Chattel, Inc. | Historic Preservation Consultants

MEMORANDUM

RE: 2501 2nd Street, Santa Monica, California
Conformance Review Addendum

NEW CONSTRUCTION - COLORS / MATERIALS

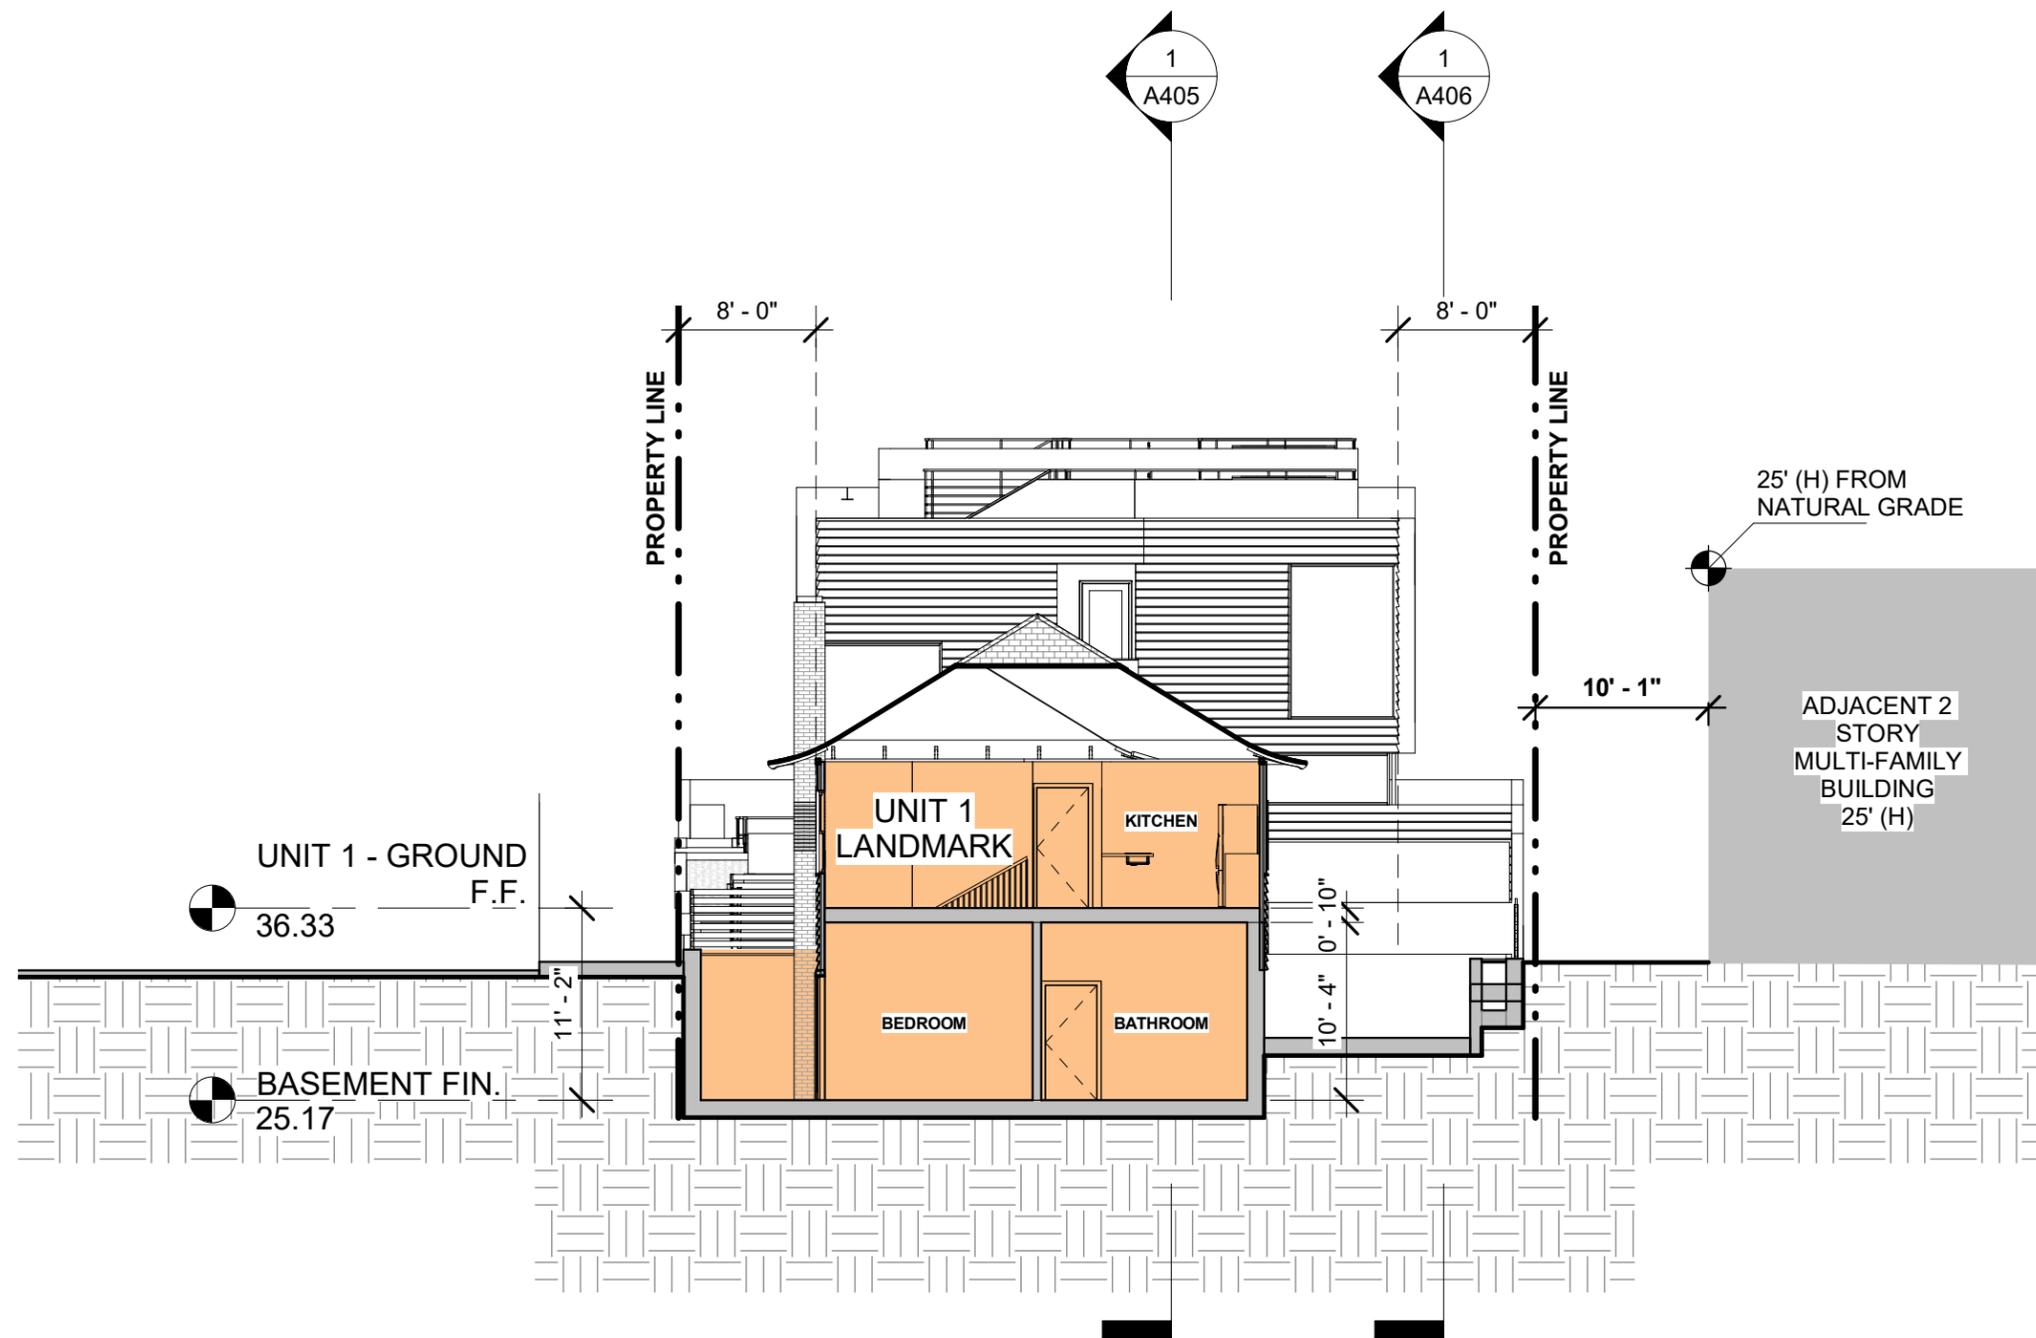
In the final drawing set, the steel towel stucco cladding is proposed to be Coventry Gray (HC-169), a medium shade of gray. The clapboard siding of the new construction is proposed to be Charcoal Slate (HC-178), a darker shade of gray meant to differentiate it from the Landmark Building in adherence with Condition 3.3 (Sheet A306). This darker color helps to ensure the new construction does not mimic the design or color palette Landmark Building, and yet remains compatible by utilizing gray tones.

Planning staff has since recommended a medium shade of gray, Gray Shower (HC 178) (sheet A306) in lieu of Charcoal Slate (HC-178).

(STAFF RECOMMENDATION)
Gray Shower
BM-2125-30
Exterior Wall Clap-board Siding,
Exposed Structure & Railing
